STRUCTURAL STATEMENT

LOCATION: Sequoia - Apartment 5.
15 Diggins Terrace, Thredbo Village.

DESCRIPTION OF WORK: Development Control Order – Ref EF 22/5385

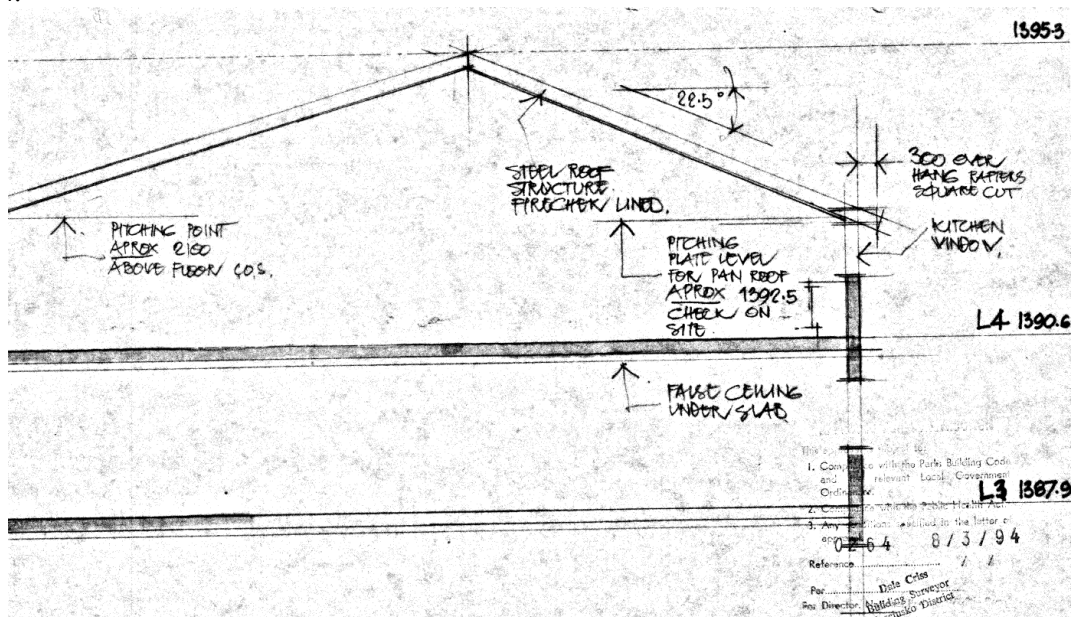
The upper floor is constructed of a concrete slab bearing on level 3 masonry walls.

Slab thickness, determined by visual inspection at service penetrations is 200mm.

Although engineering details are not recorded, the architectural intent for the upper floor slab is shown below; and in the plans attached, which are taken from a DA submitted in 1994.

Concerns have been raised by Dept Planning representatives, about loads imparted by the addition of timber wall linings to internal walls; and, about the installation of new baths in the bathrooms.

The wall lining selected is 12mm thick hardwood which has a mass of 11.8kg/m². Even the worst-case wall, the media room wall has 8.1m² of cladding, generating a distributed load of 0.32 KPa, one fifth of the required design capacity for imposed loads.

The baths selected also generate minimal loads, which do not exceed the design loads used for design of suspended slabs in general areas.

The larger bath has a water capacity of 158 litres. Allowing for framing, linings and tiles, the constructed bath generates a distributed load of 1.25 KPa, safely within the required design loads. It should also be noted that the 1994 renovation also specified baths.

In conclusion, in accordance with Item 5(b) of Schedule 2 of the Precinct Regional SEPP, the current works proposed do not alter any load bearing member of the building, nor do they result in the load bearing capacity of a member being exceeded.
